From: Bill Bardenwerper <wbb@bardlaw.net>
Sent: Tuesday, August 19, 2014 1:04 PM
To: Carroll, John G.; Baker, Jonathan; Reverman, Joe; Liu, Emily
Cc: Stpinlou@aol.com; Nick Pregliasco; gcrawfordjr@yahoo.com; Mark Madison (markmadison@milestonedesign.org)
Subject: Crawford's Rosewood condominiums; Case No. 14PARK1002

**ROSEWOOD ASSOCIATIONS' SUMMARY OF OMITTED & INEFFICIENT DATA
RELATED TO HRG'S REVISED 7/21/14 SITE PLAN**

SUMMARY OF OMITTED, INSUFFICIENT, INACCURATE, AND MISLEADING DATA RELATED TO HRG'S SITE PLAN, WAIVER APPLICATIONS, AND PARKING STUDY

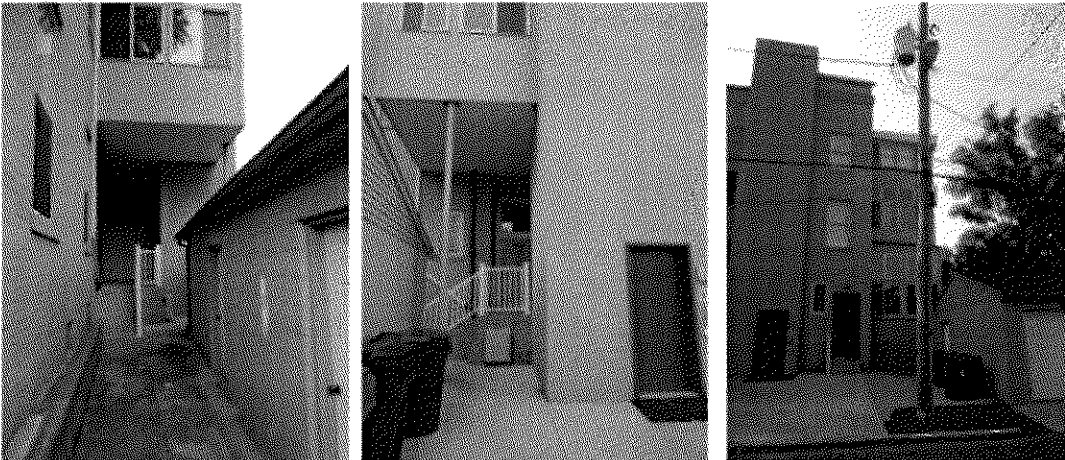
The site plan should provide precise measurements for all claimed PYA in order to verify if HRG actually meets the claimed 3,696 sq ft. The identified areas claimed as private yard cannot possibly add up to this value.

In addition to those identified violations, the expansion of the claimed PYA further violates Code:

- a. It appears that HRG is including the 560 sqft. "Rooftop Garden" in the total PYA of 3,696. Based upon our February meeting with the directors of C&R and PDS, the roof deck was explicitly disallowed. Have the directors revised their position? Either way, HRG must exclude the roof deck from the PYA or apply for a waiver.
- b. Does the area marked TBR mean "to be reviewed"? If so, please note that Section 5.4.1.E.2. requires a minimum rear setback of 5 feet "that *cannot* be counted toward the private yard requirement." [see attached photo of site plan. Approximate 5 ft. line depicted by dotted red line]. HRG must exclude the 5 ft. rear set back or apply for a waiver. Also note that the site plan does not identify the utility pole/transformer located on the left side of the service area [see below photo].

- c. Section 5.1.7 states that "every part of the required yard shall be *open to the sky*." There are two areas claimed as PYA that are completely covered by the floor area of an enclosed rear sun room on the second floor [see attached photo of site plan. Areas outlined in red are covered by the sun room as depicted in below photos. Utility area is also outlined in red]

Very specific PYA measurements would be extremely helpful. The site plan does not indicate how HRG can meet the minimum PYA requirement of 3,592 sqft. Based upon measurements from previous site plans, the disallowed areas in red and black are over 700 sqft. If the roof deck is also rightly excluded, that's another 560 square feet. HRG is short at the very least by 1,260.

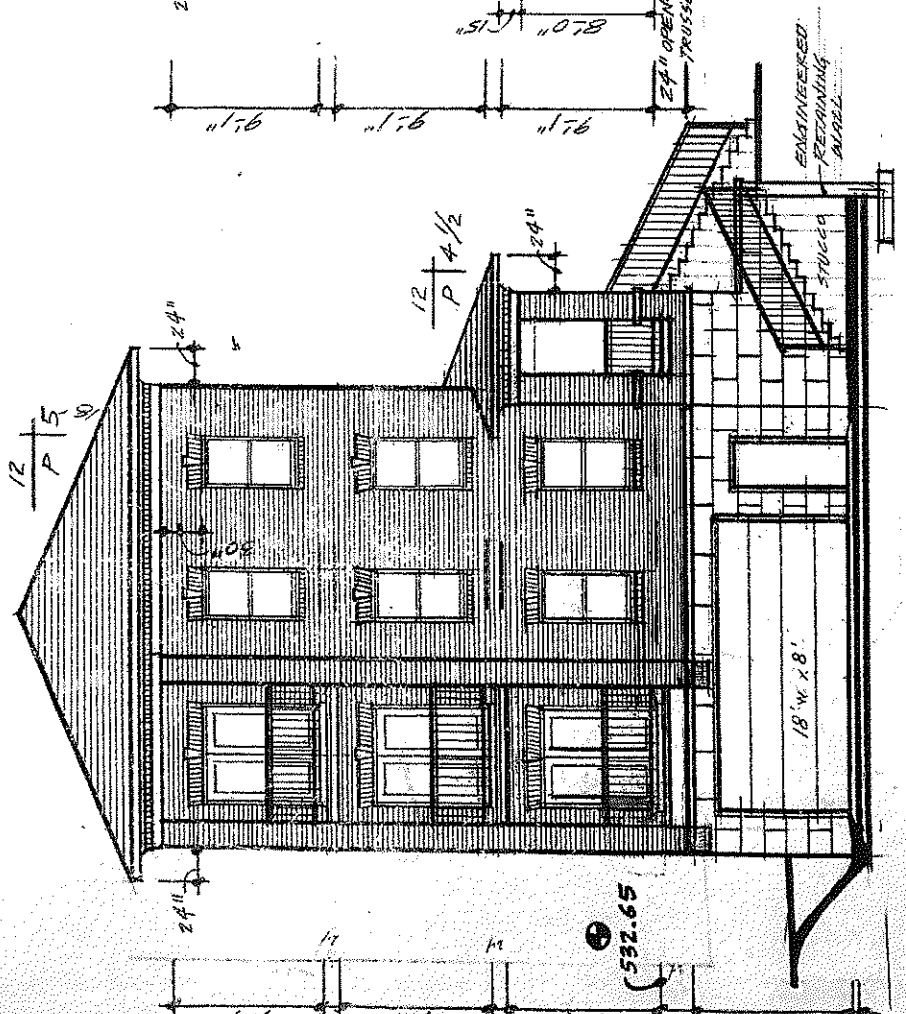
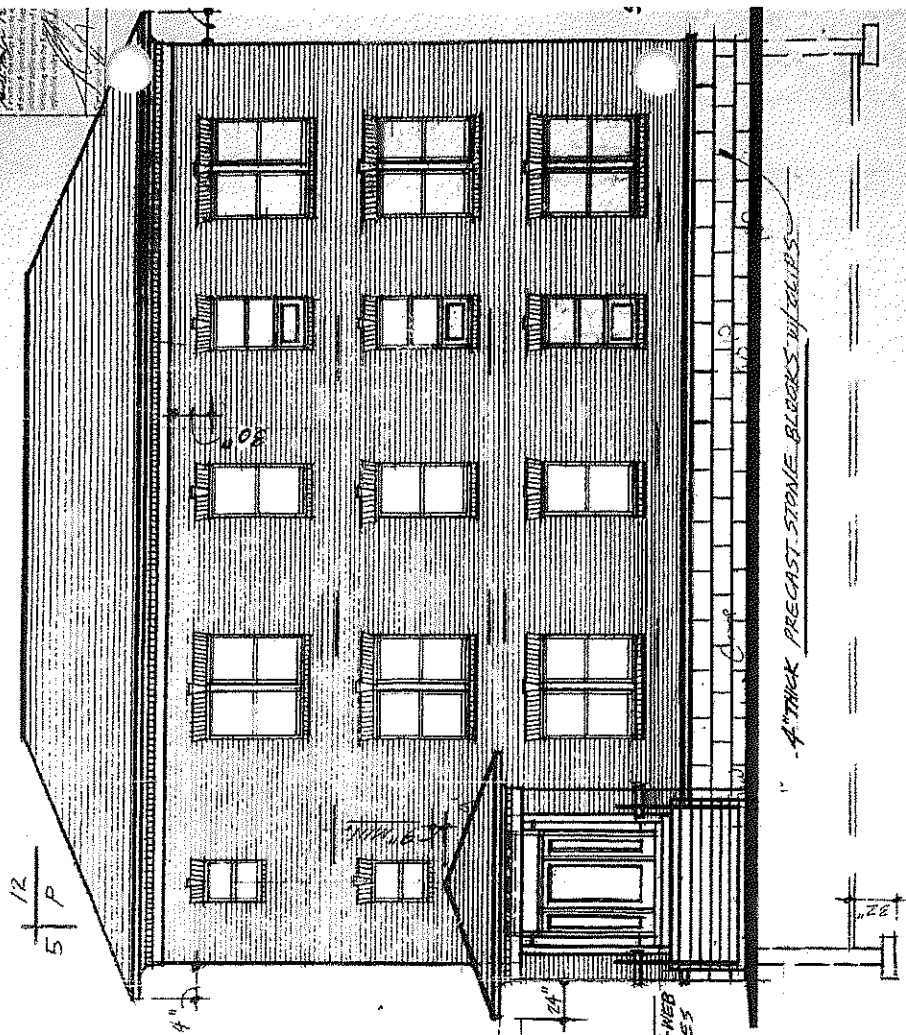
Could you please verify some required dimensions that are missing from the revised site plan?

1. the distance of the front setback from the front property line to the building's facade
2. the dimensions for both the porch and front steps area
3. the length of the front building facade (I know that it measures 28 ft. in the back but previous plans showed a narrower front with the building expanding slightly in the rear).
4. the building's exact physical height from its foundation to the highest point of the roof
5. whether there will be a grade change that would effect how tall the building would eventually stand
